MAYFLOWER PLATINUM

Details of Additions & Alterations

Flat No	605	Block no.	'A'
Flat Area	1500 sft	Type	Deluxe / Luxury ✓
Buyer Name	Mamilla Sunitha		
Phone No.	9396848457/8790326282(C)	Email	mamilla_ss@yahoo.com

Description	Direction	Owners & Developers :	Date :	Promoted by
WORKING DRAWING OF FLAT.NO. A-5	N	Modi Properties Pvt Ltd.	18.03.2020	Modi Properties Pvt. Ltd
	Project Name & Phase :	JAYFLOWR PLATINUM	Prepared By :	Phone: +91-40-66335551
			Approved By :	
			Sca.	N.T.S

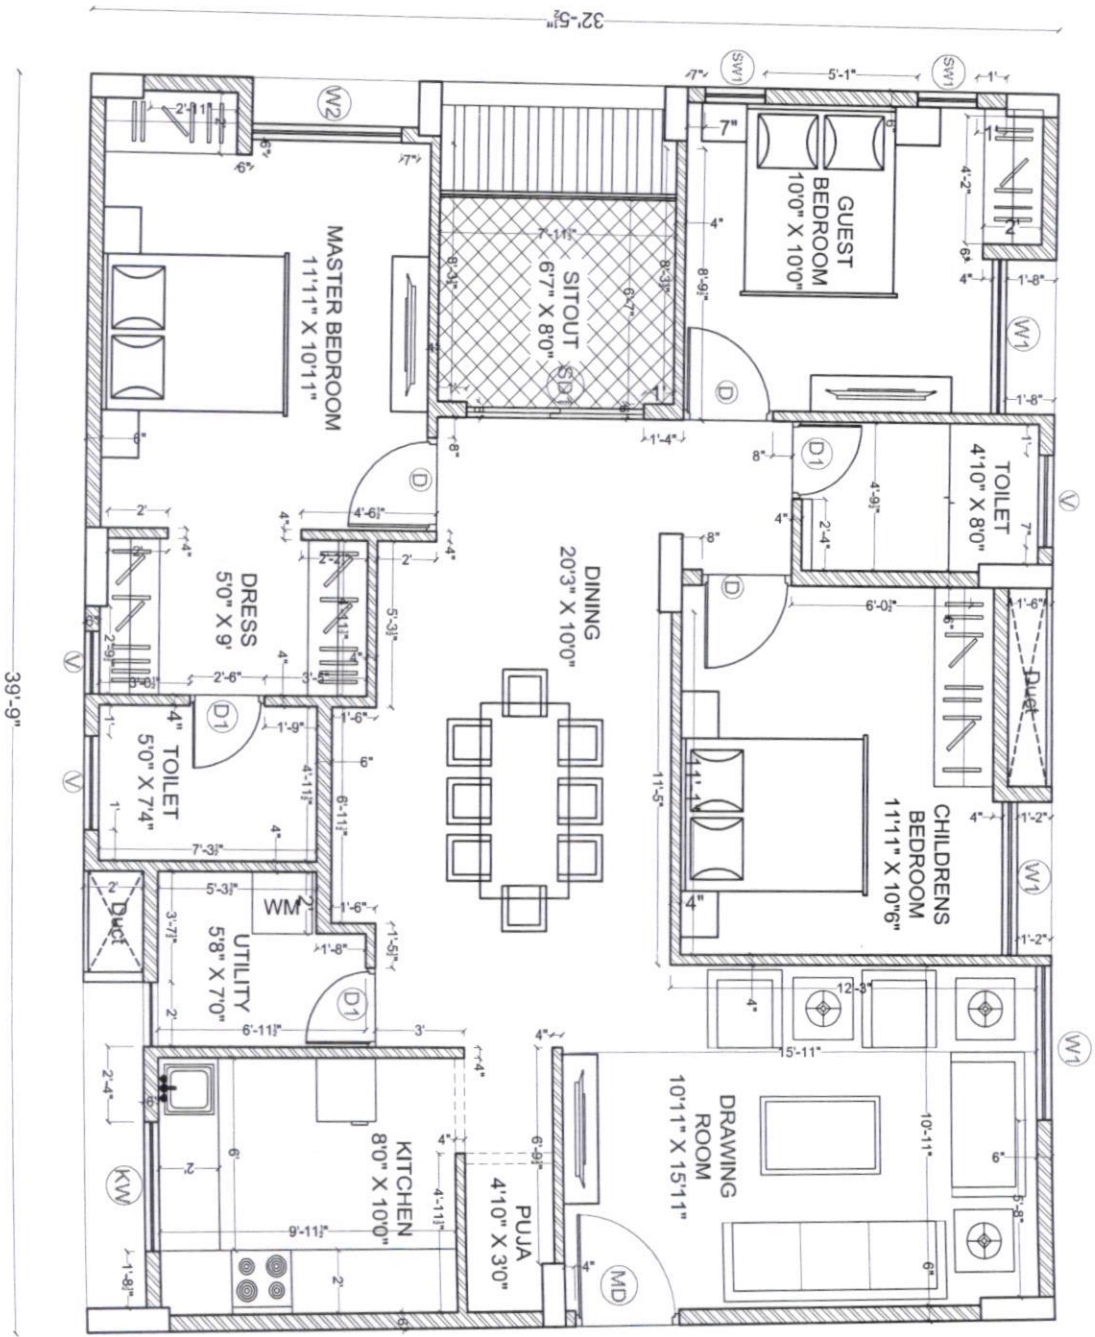
Changes in flooring:

2 Bed room 2x2 vertised, Drawing & dining & puja
Same as model flat A 105

→ balcony & utility same as model flat A 105

→ MBR wooden tiles.

Changes in kitchen platform: (mark on plan)

Same as modular plat.

ELECTRICAL PLAN OF FLAT-A5

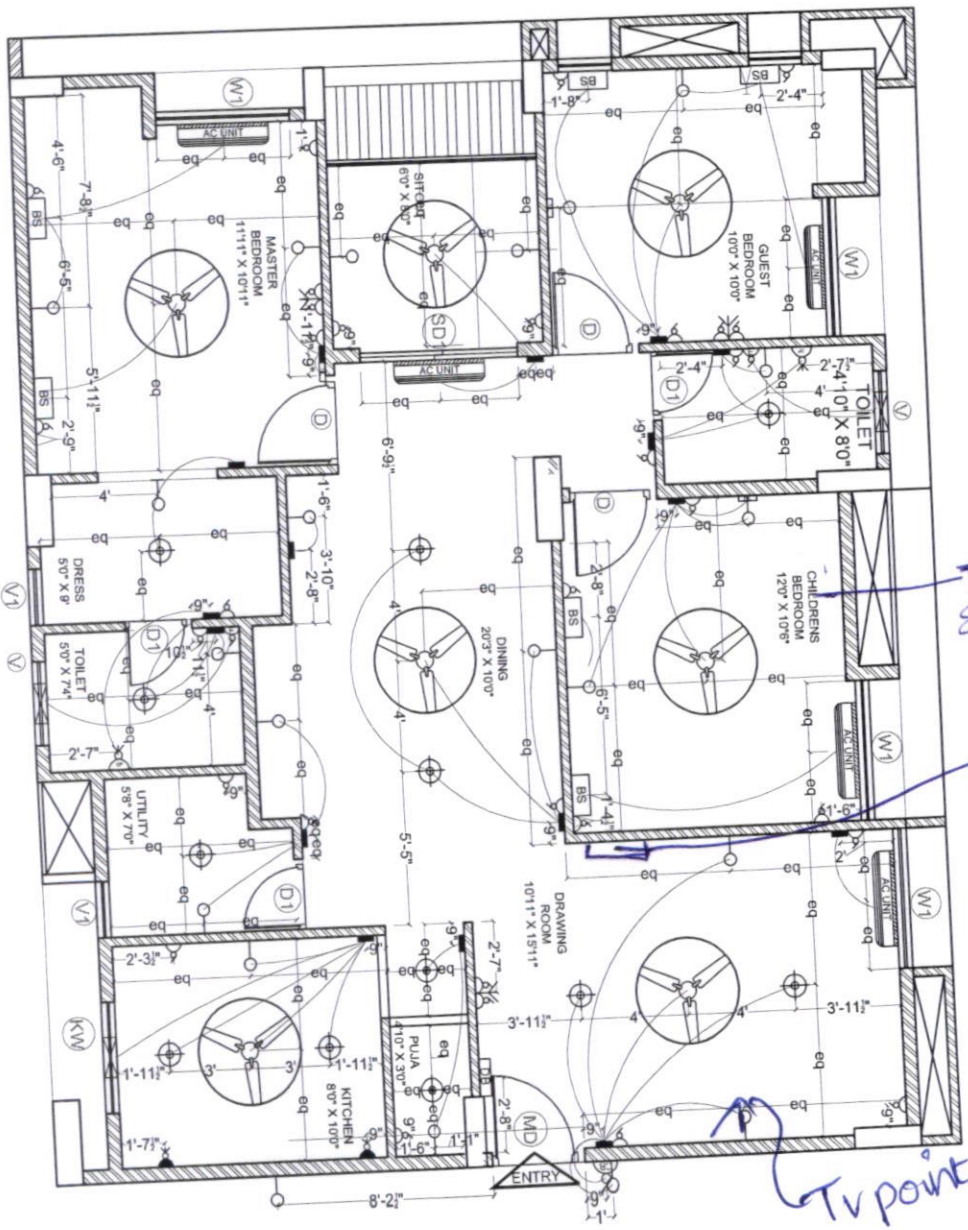
Changes in electrical points: (mark on plan)

Extra 3 point at marked on plan.

TV point extra

6 model extra

TV point

2. Small alteration of TV point to be given at right side of the wall of Entrance instead of left side you are providing.

Description	Direction	Owners & Developers :	Date :	Promoted by
PLUMBING PLAN OF A5	N	Modi Properties Pvt. Ltd.	09.01.2020	Modi Properties &
		Project Name & Phase :	Prepared By :	Investments Pvt. Ltd.
		Mayflower Platinum	Approved :	Phone:+91-40-66335551
			Scale :	
			N.T.S

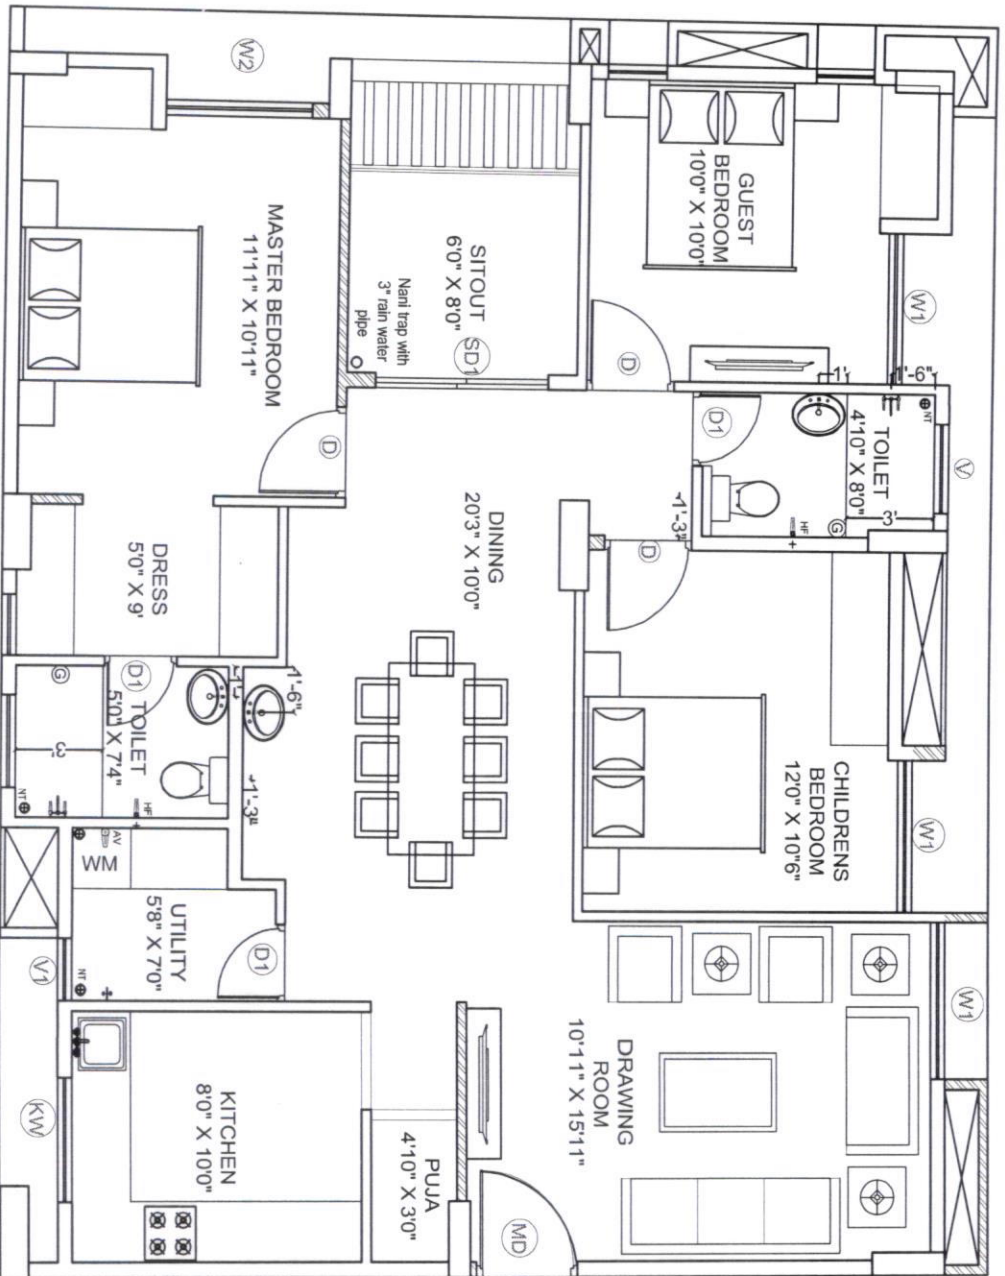
no changes
06/06/2020

3. Very small alteration of the plumbing work which will be advised at the time of fixation.
